DESCRIPTIVE REPORT

Type of Survey ... Hydrographic
Field No. RA-10-03-99
Registry No. H-10862

State Alaska
General Locality . Lynn Canal
Sublocality North Island to Vicinity
of Point Bridget

Descriptive Report to Accompany Hydrographic Survey H-10862

Illustration 7. Prior H-2056 vs. H-10862

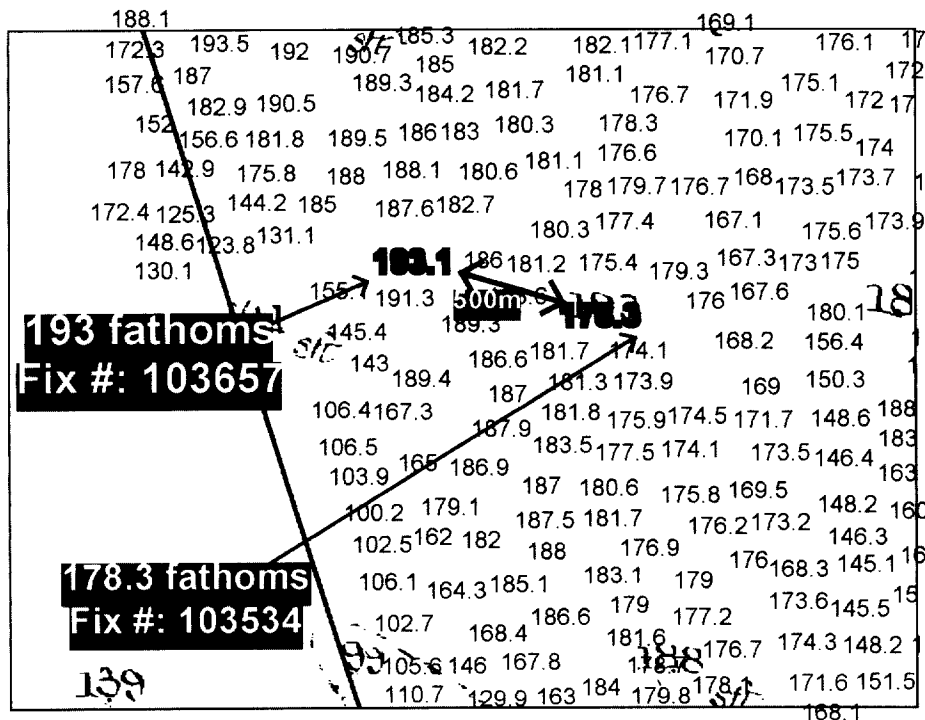
H-2056 Depth (fm)	H-10862 Depth (fm)	H-10862 Fix #	Geographic Position	Comments
12 1/4 ✓	2.5 ✓	71066	58° 35' 34.9" N ✓ 135° 01' 22.6" W	Present survey shows shoalest sounding for the position of prior sounding (see Illustration 6.).
45 ✓	37.2 ✓	72271	58° 37' 23.3" N ✓ 134° 59' 46.617" W	Present survey shows shoalest sounding for the position of prior sounding. Concur
193 ✓	178.3 ✓	103534	58° 37' 31.4" N ✓ 135° 03' 28.233" W	Depth from present survey in immediate area of charted prior sounding (see Illustration 7). Concur
" " ✓	193 ✓	103657	58° 37' 31.6" N ✓ 135° 04' 01.477" W	Position of prior sounding (193-fm) is incorrect – Hydrographer recommends using present survey location for 193 fm (see Illustration 7). Concur

Illustration 9. Prior H-2056 vs. H-10862

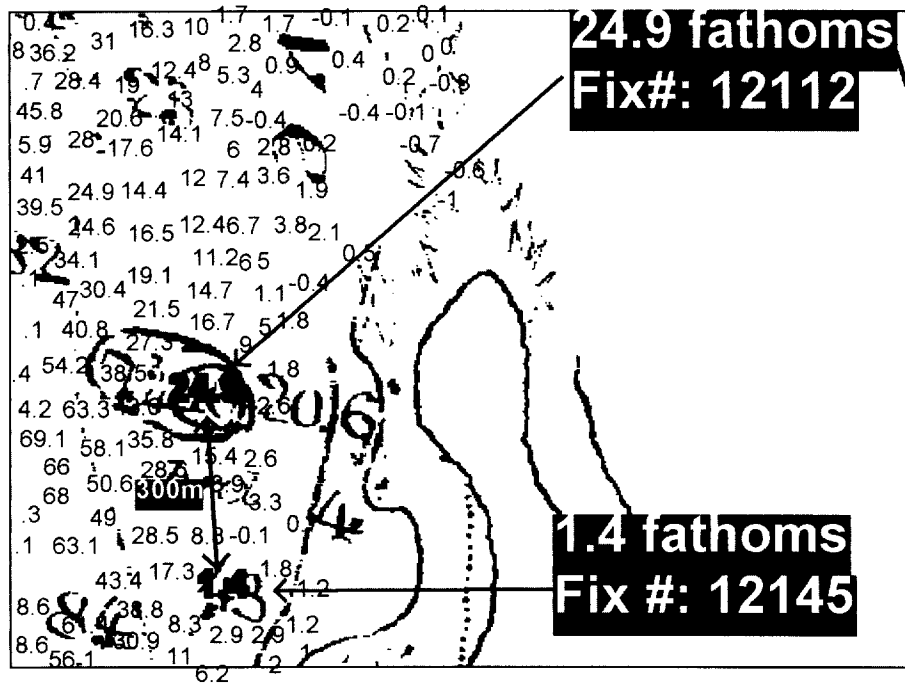
27 22 ✓	24.5 ✓	72078	58° 36' 32.9" N ✓ 135° 03' 13.532" W	Present survey shows shoalest sounding for the position of prior sounding. <i>Concur</i>
188 ✓	108.6 ✓	94954	58° 36' 59.9" N ✓ 134° 59' 32.162" W	Depth from present survey in immediate area of charted prior sounding (see Illustration 8) <i>Concur</i>
" "	188.2 ✓	91842	58° 36' 47.4" N ✓ 134° 59' 57.627" W	Position of prior sounding (188-fm) is incorrect – Hydrographer recommends using present survey location for 188.2 fm (see Illustration 8) <i>Concur</i>
10 feet	24.9-fm	12112	58° 37' 19.3" N 134° 56' 48.3" W	Depth from present survey in immediate area of charted prior sounding (see Illustration 9) <i>Concur</i>
" "	1.4-fm	12145	58° 37' 09.7" N 134° 56' 42.9" W	Position of prior sounding (10 feet) is incorrect – Hydrographer recommends using present survey location for 1.4 fm (see Illustration 9) <i>Concur</i>

Illustration 10. Princess Sophia Wreck

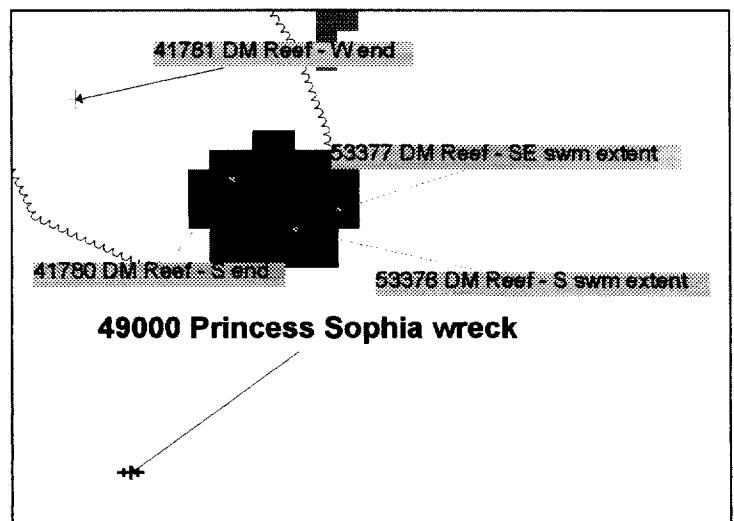
METHOD OF INVESTIGATION: Dive for Least Depth
Least Depth: 13.84 m (7.57 fathoms); Range: 0m, Bearing 308M *
FINDINGS: Wreck, Submerged

The hydrographer does not find the wreck to be a danger to navigation. It is of interest for cultural purposes only. *Concur*

* Least depth based on actual tides is 13.04 meters (7.1 Fathoms)
